**APPLICATION TO THE ZONING BOARD OF ADJUSTMENT**

## Denial Memorandum

**Applicant:** Derek Serpe  
**Property Address:** 36 East River Road, Rumson, NJ 07760  
**Block, Lot & Zone:** Block 11, Lot 12, Zone R-2

I have reviewed the Zoning Board application for the construction of 350-sf poolside cabana with outdoor shower at 36 East River Road in Rumson. The existing lot is an oversized, internal, conforming lot in size and shape. In 2025, a Land Use & Development Permit was issued for a new, conforming, single-family dwelling which is currently under construction.

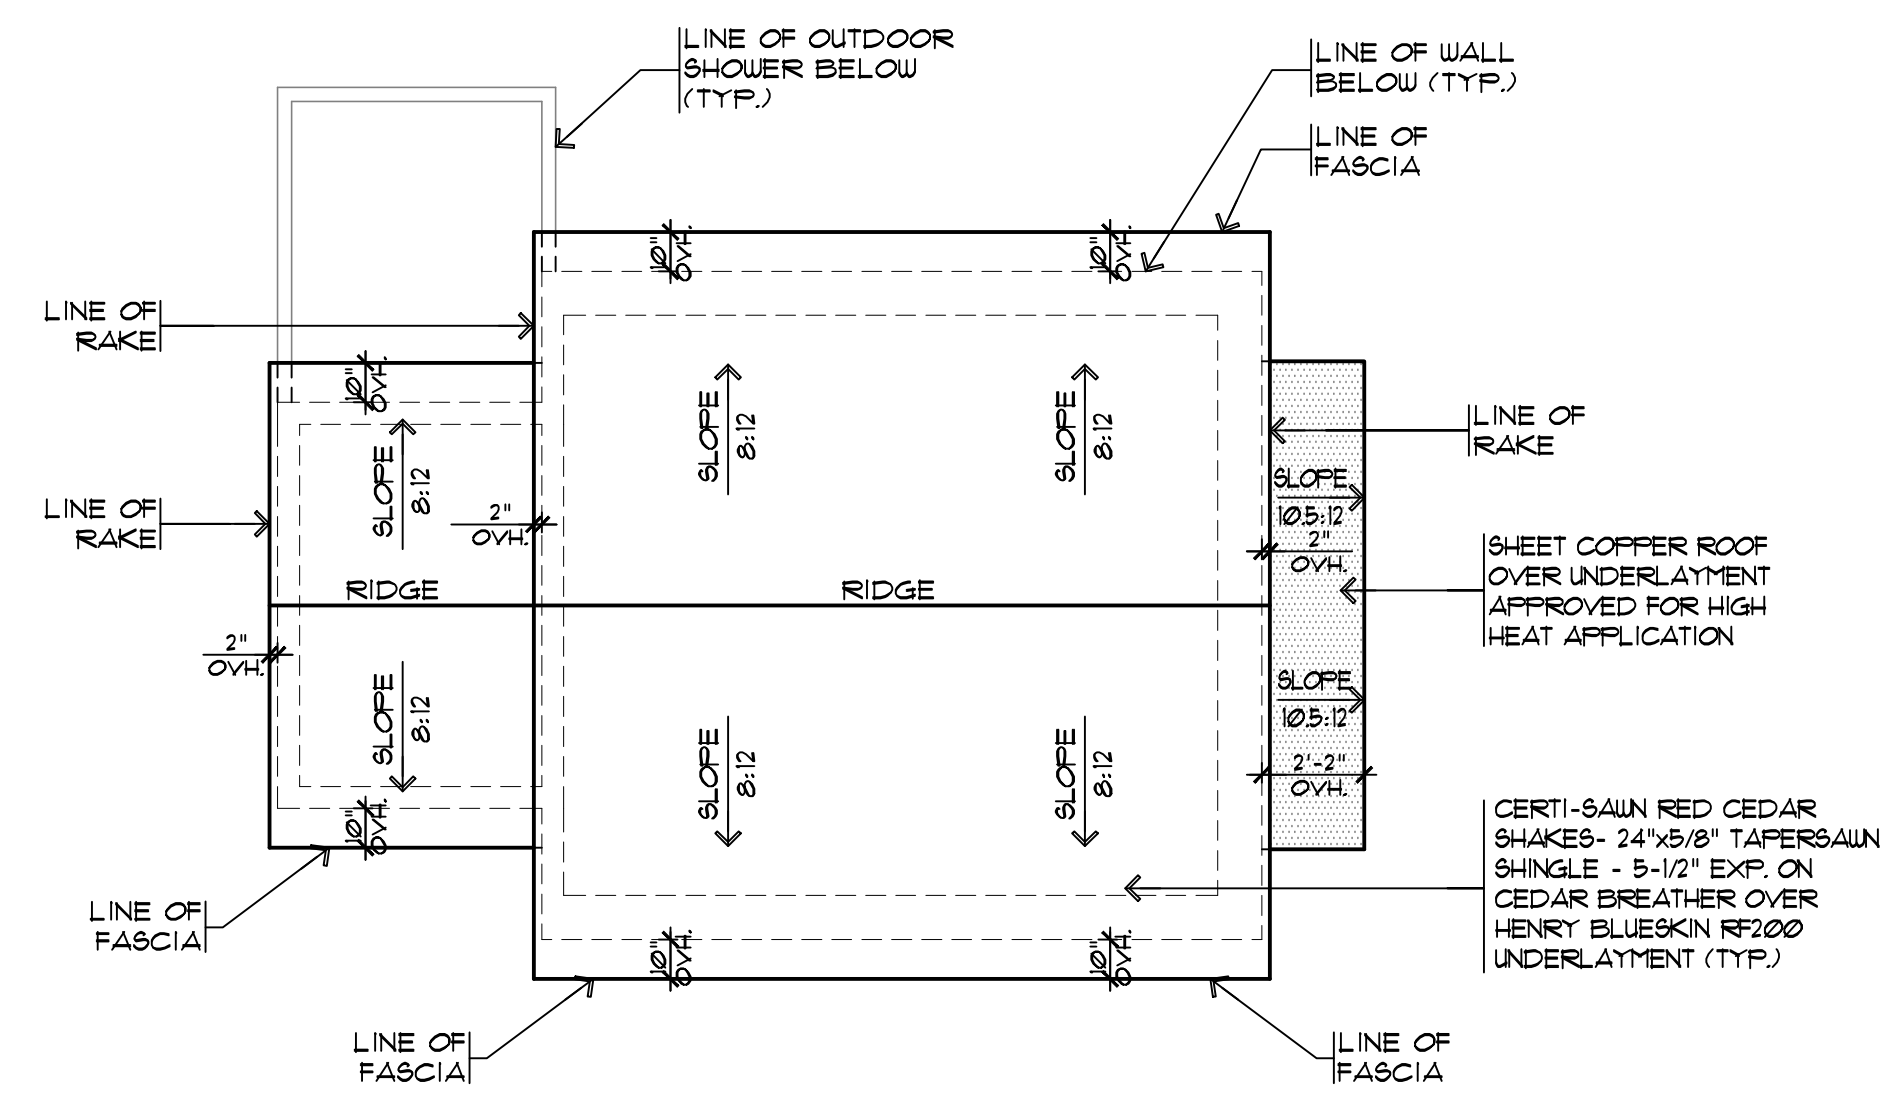
The proposed cabana was **denied** for the following non-conformities:

- Residential accessory pools and any associated accessory building shall maintain a minimum setback of twenty-five (25') feet the R-2 zones (**22-7.8g New Variance**)
